SITE PLAN FOR: JIM EVANS
BEING A 1.420 ACRE PARCEL
TOWNSHIP OF CONCORD
COUNTY OF LAKE
STATE OF OHIO

DRAWN BY:	SRL	DATE:	8/94
CHECKED BY:	JFT	DRAWING NO:	AZT-060
SHEET:	1	OF:	1

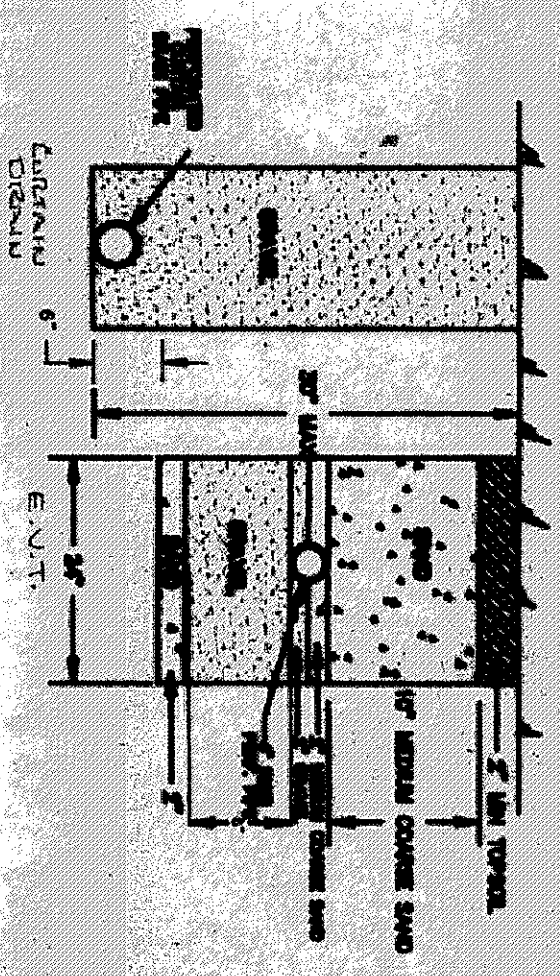
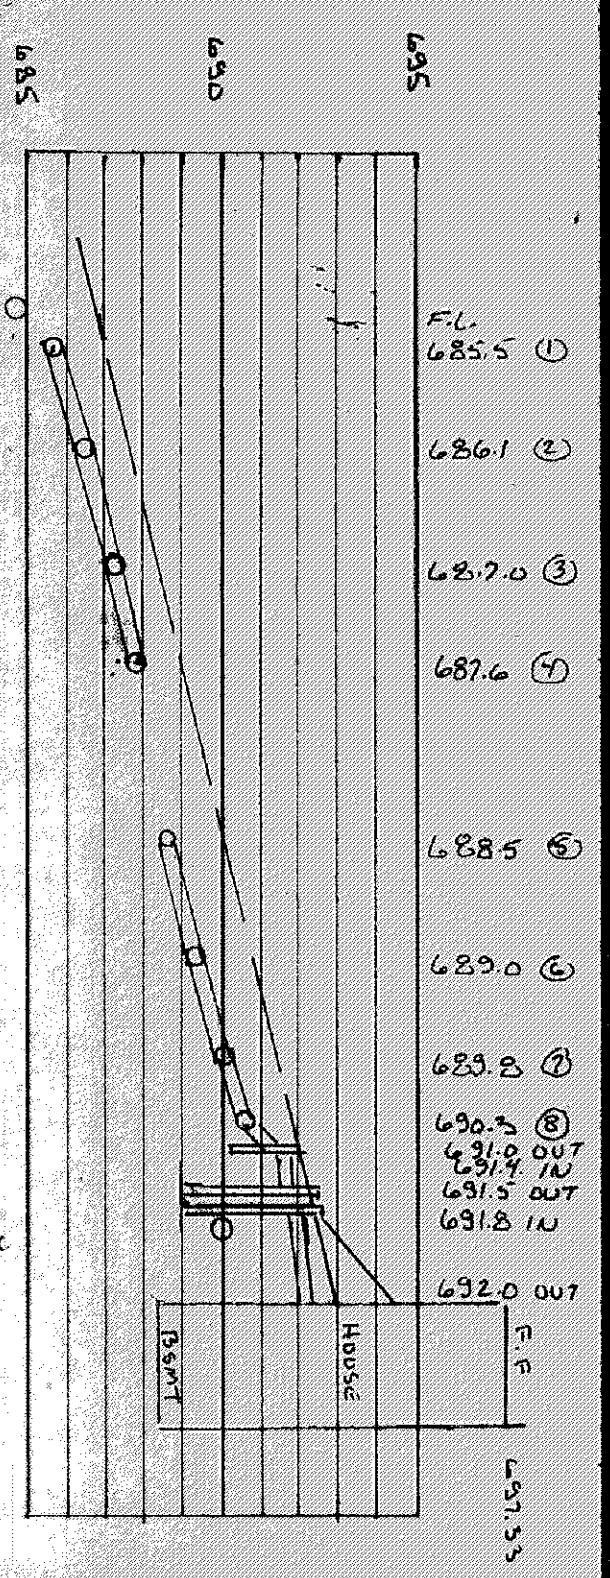
By: *Jim Evans*
Date: 10-14-94
Drive culvert shall be sized by 0007.
